Staff Summary Report

Development Review Commission Date: 05/08/07 Agenda Item Number: ___7 ___

Development Overlay, and Development Plan Review for 5TH STREET WEST

DOCUMENT NAME: DRCr_5thStreetWest_050807 **PLANNED DEVELOPMENT (0406)**

FARKING DEMO - BACK UP

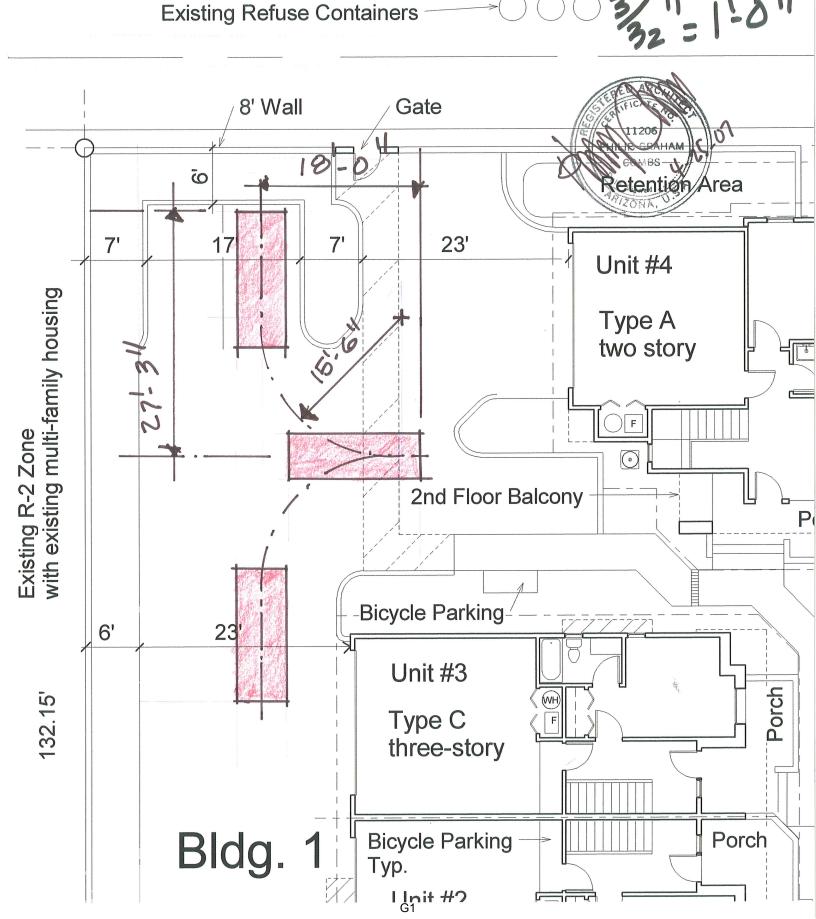
Staff has been unable to come to a consensus with the applicant on reconfiguring the parking and garage access layout at the northwest of the site. Based on the existing parking configuration, the City's Traffic Engineer and Planning staff recommends modifying the northwest parking layout to avoid conflicts with vehicles and pedestrians, and limit potential areas for unauthorized parking near the pedestrian gate and garage. Staff's recommended layout modification, as shown within Attachment H, will provide the following benefits:

- 1. Allows vehicles to exit the site by forward motion;
- 2. Removes area which may encourage unauthorized parking that would block access out of the garage and block pedestrian access to the alley:
- 3. Places the pedestrian pathway out of conflict from vehicles so that residents may access the refuse in the alley;
- 4. Provides one additional parking space;
- 5. Reduces the amount of asphalt drive; and
- 6. Relocates the garage access to the north, increasing alley use and potentially limiting undesirable activity.

- 9. Reconfigure surface parking area to the west by providing four (4) parking spaces perpendicular to the drive aisle, including a six (6) foot sidewalk leading to the alley, as shown on staff example.

STAFF RECOMMENDED LAYOUT OH

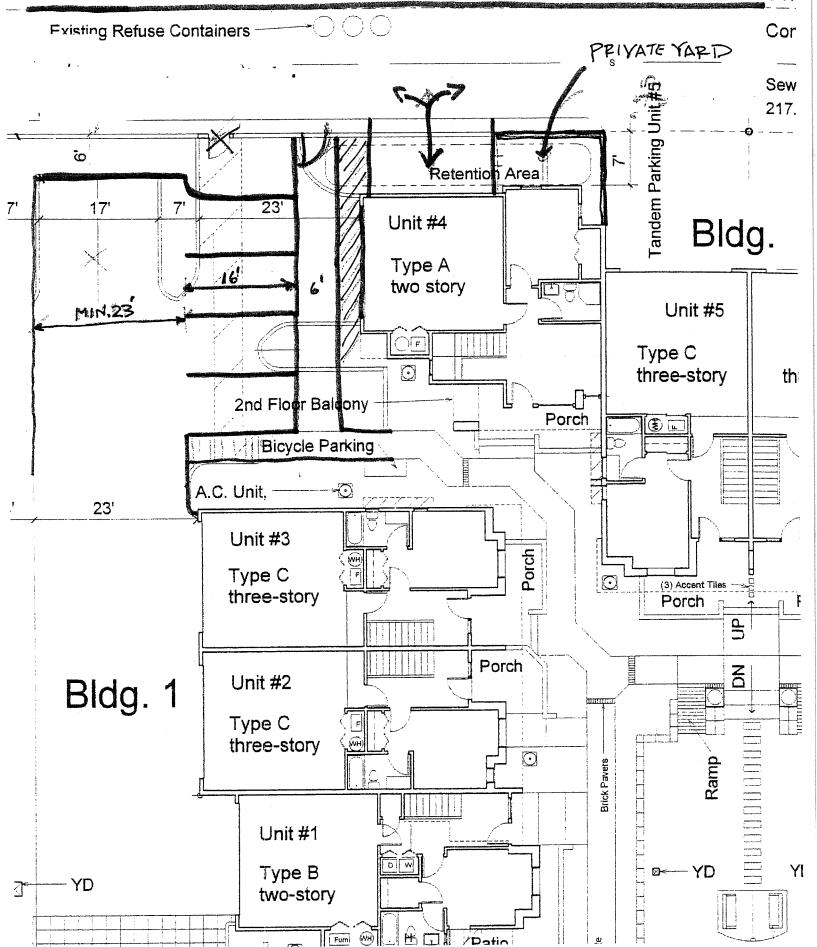
Previous configurations of the eastern parking area have evolved through revisions and expansion of the project area to provide an acceptable parking configuration. Staff is hopeful an alternate parking layout will be provided as noted in the conditions, which is similar to the eastern parking configuration.
